SOUTH END LANDMARKS COMMISSION

587 ALBANY STREET

Project Overview

RE: 587 Albany St. Boston, MA **Conceptual Structural Pricing Narrative** H+O Project #24-022

STRUCTURAL REPORT AND PHOTOS - 06/28/2024

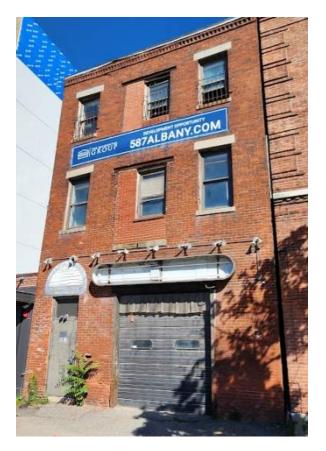
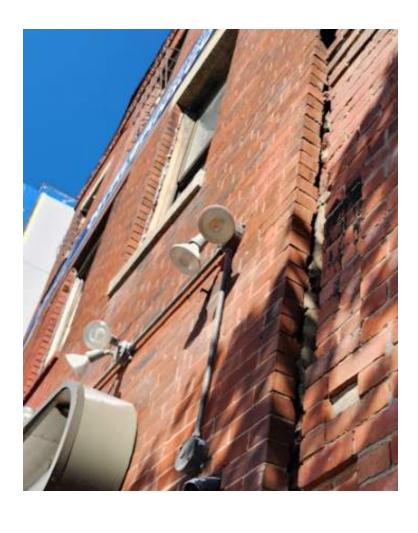
The existing structure is a 3-story unreinforced brick masonry building, a common construction type from this time period. The attached photos show several deficiencies observed during our visit. There was extensive loss of mortar, step cracking, and loose and missing bricks. At approximately the elevation of the second level, the outer wythe of masonry has pulled away and delaminated from the inner wythes. All of the above have created paths for water to enter the façade and further degrade it over time.

Of most concern, the back of the façade has pulled away from the framed second floor by about 3-5 inches. This is substantial movement, and we did not observe any floor ties, which suggests the façade currently has no bracing to prevent further movement.

There is planned redevelopment for this parcel that was intended to brace, restore, and reattach the façade to the new building. In our opinion, this façade cannot be safely braced and repaired in that manner given its out-of-plumbness and deteriorated condition. We suggest the full demolition of this wall and rebuilding or reincorporating it as a brick veneer in the new project.

This matter must be addressed promptly, as the current condition is unsafe. We recommend engaging a demolition and shoring contractor familiar with this type of work and installing appropriate sidewalk protection immediately.
